Review of Ergon Energy's revised regulatory proposal for the period July 2010 to June 2015

May 2010

for the Australian Energy Regulator

Figure 2.1 2009 sub-transmission augmentation portfolio composition (by number of projects)

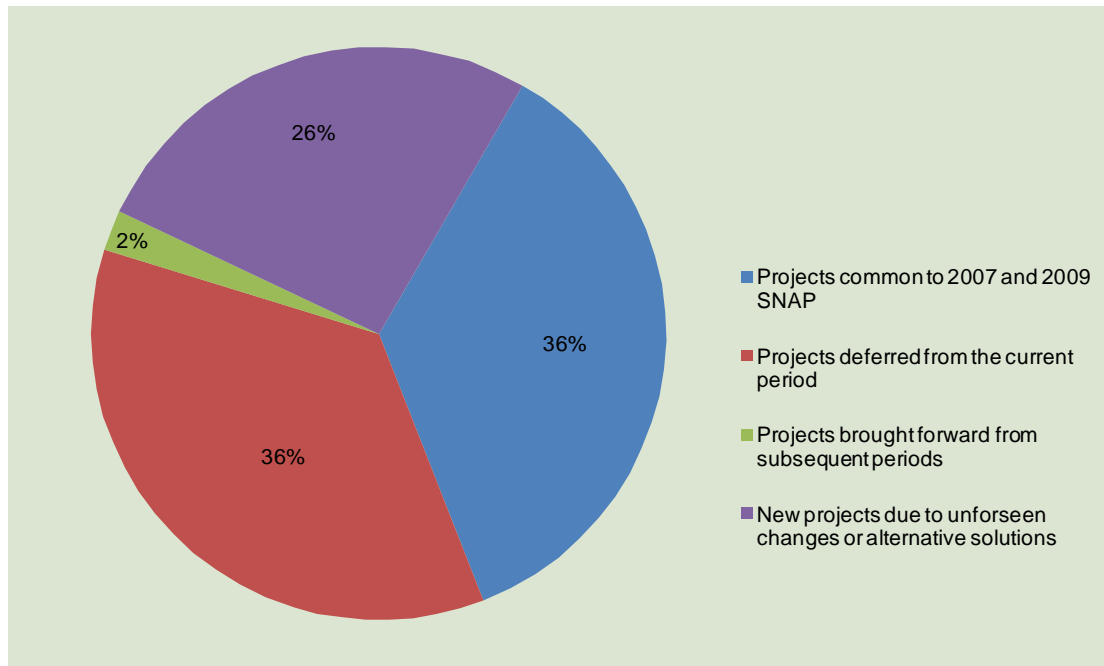
Ergon Energy's findings are summarised in Figure 2.1, below.

Given the significant changes between the 2007 and 2009 planning documentation, which are stated by Ergon Energy to have been prepared on the basis of the same security criteria⁴⁹ and notably the same aggregate demand forecast⁵⁰, PB is of the view that the large deferrals result from the insufficient consideration of project timing or alternative options in the planning stage of sub-transmission projects. In particular, the lack of preliminary business cases, or similar documentation, to inform medium term planning decisions appears to have had a material influence on the variability and volatility of the expected composition of Ergon Energy’s capital program over the next regulatory control period - with only a 35.7% correlation between the 2007 and 2009 capital program. We note that even this figure is based on whether the project is within the five year period, and not necessarily whether the timing is the same.

Figure 2.2 Historical and Proposed CIA Capex

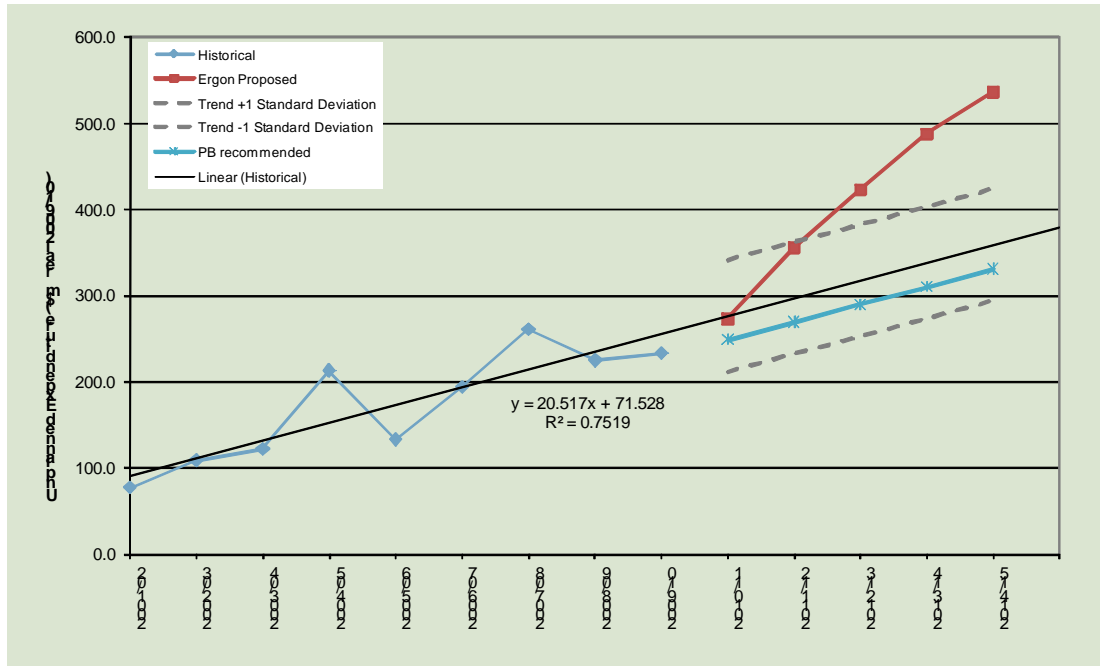
PB has recalculated the 18 month (30%) forecast adjustment having regard for the deferral of the forecast recommended by MMA and taking the midpoint of the range of non-forecast driven CIA capex of 70.9% advised in the Huegin report. This results in a recommended value of \$1,450.8m for CIA capex, an average of \$290.2m per annum, across the next regulatory control period. Due to the steep annual growth in CIA capex proposed by Ergon Energy and the effect of the deferral adjustment, a direct scaling of the proposed capex does not provide realistic distribution of expenditure over the period, with expenditure unfavourably weighted towards the latter years. Therefore an alternative high level approach has been adopted for Ergon Energy in order to provide a more realistic spread of expenditure across the period. To arrive at an annual adjustment, PB has spread the adjustment across the period in accordance with the long term linear growth trend in CIA capex of \$20.5m per year over the period 2001/02 to 2009/10 as shown in Figure 2.2.

PB notes that accounting for the recommended \$625.5m adjustments, the CIA capex amount of \$1,450.8m represents a 33% real increase over the \$1,093m historical CIA capex identified by Ergon Energy for the current regulatory control period in its revised regulatory proposal. PB’s recommended CIA capex is shown in Table 2.4.

PB has reviewed Ergon Energy's revised proposal, and we have concluded that the new and additional information provided does not demonstrate that the revised CIA capex proposal is prudent and efficient. Consequently, PB recommends that the AER apply the adjustments shown in Table 2.5 to Ergon Energy's revised proposal to account for the likelihood of ongoing deferral of subtransmission development projects, and to account for the impact of reduced aggregate demand forecasts as informed by the MMA review.

Figure 2.3 Long term replacement capex comparison

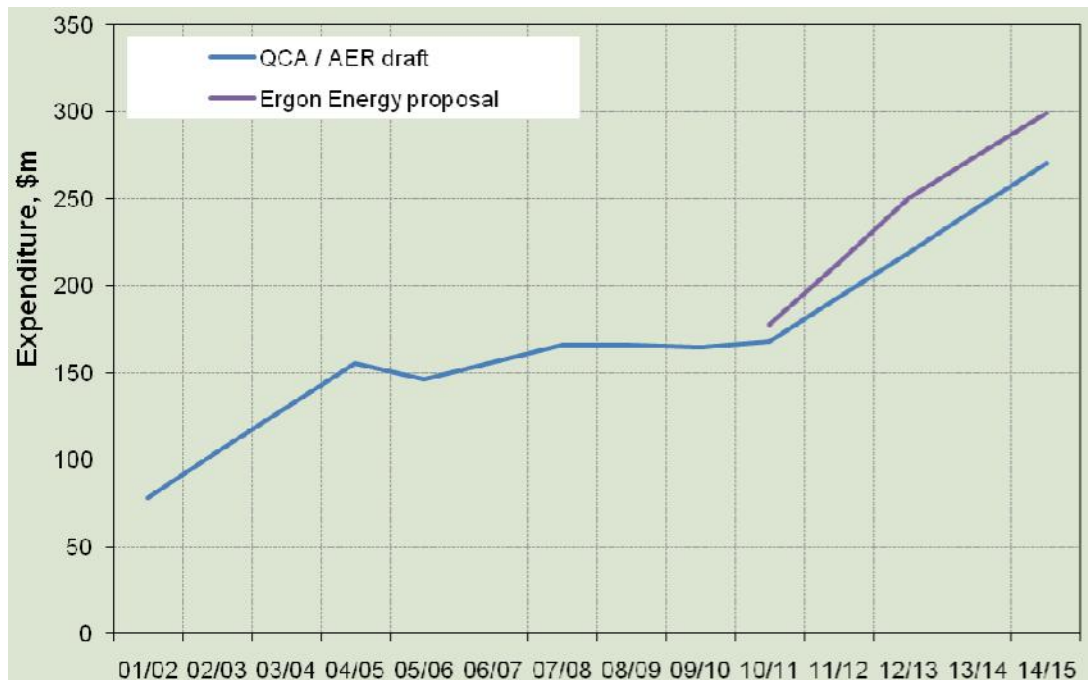
While PB recommended a business-as-usual level of expenditure, this was determined using the observable historical growth trend across the 2001/02-2004/05 period. We note that the historical growth trend for replacement capex is explainable in terms of Ergon Energy's amalgamation history, and that this expenditure growth was addressed in the QCA's last review. PB used this trend in calculating the business-as-usual expenditure to 'smooth out' the volatility of the historical expenditure. This trending can be seen in Figure 2.3 which shows a comparison of Ergon Energy's replacement capex proposal and the QCA approved and AER draft determination replacement capex. PB is of the view that by adopting this growth trend approach, Ergon Energy's historical under expenditure is reasonably accommodated within the forecast trend. This can be seen by considering the total long-run investment in asset replacement, which totals \$2.41b between 2001/02 and 2014/15 under Ergon Energy's proposed expenditure level, compared to \$2.36b based on the QCA approved investment and the AER's draft determination. Hence, the difference in the long run investment is 1.7% below that proposed by Ergon Energy. Moreover, PB notes that while Ergon Energy's proposed replacement capex represents a real increase of approximately 72% over the current period, the business-as-usual capex in the context of the longer term average nonetheless represents a real increase of 55% over the current period.

Figure 4.1 Ergon Energy direct costs associated with forced maintenance for sites and corridors

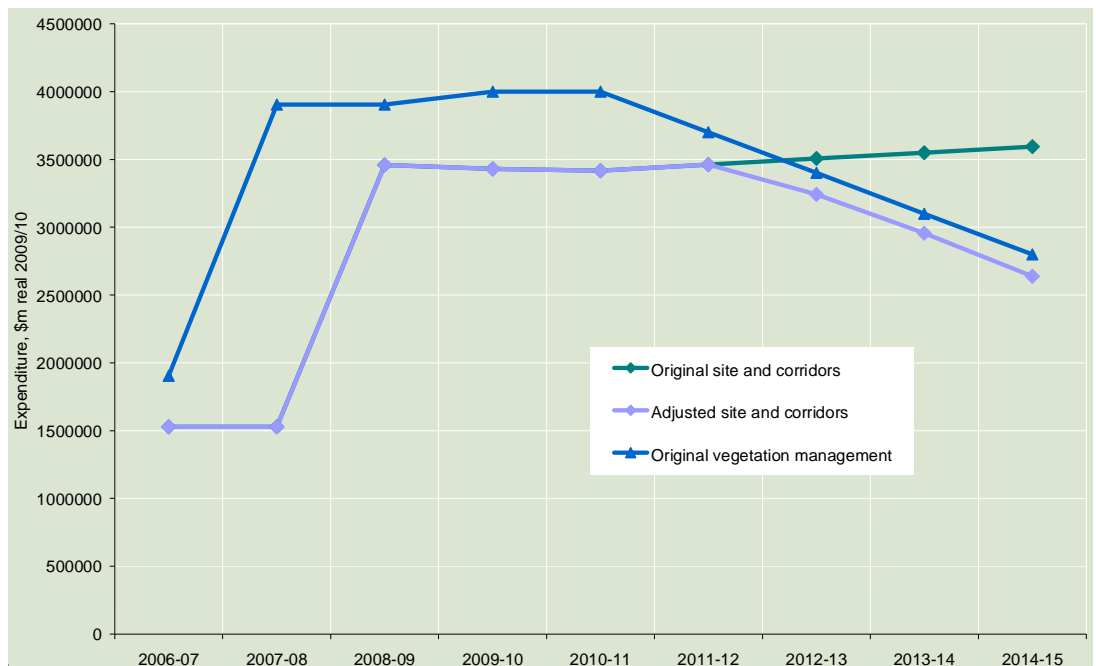
- Whilst the aggregate forced maintenance opex was held fixed by Ergon Energy at approximately \$27.2m per annum (direct costs) across the next regulatory control period, the modelling implicitly reduced the forced maintenance requirements associated with vegetation management on the basis of its significant increase in preventive and corrective maintenance in this area and its updated strategy. This detail was presented in Figure 6.6 of PB's original report and reproduced in Figure 4.1 below.

PB quantified its adjustment to the forced maintenance opex allowance by a) removing all growth in the 19 asset classes after 2010-11 where this was modelled by Ergon Energy, and b) applying the same principle to Ergon Energy's corridors and sites forced maintenance opex as it had modelled for the vegetation management asset class, given that it was also introducing a new proactive preventive and corrective maintenance program for these assets. This later adjustment was explicitly shown in Figure 6.6 of PB's original report.
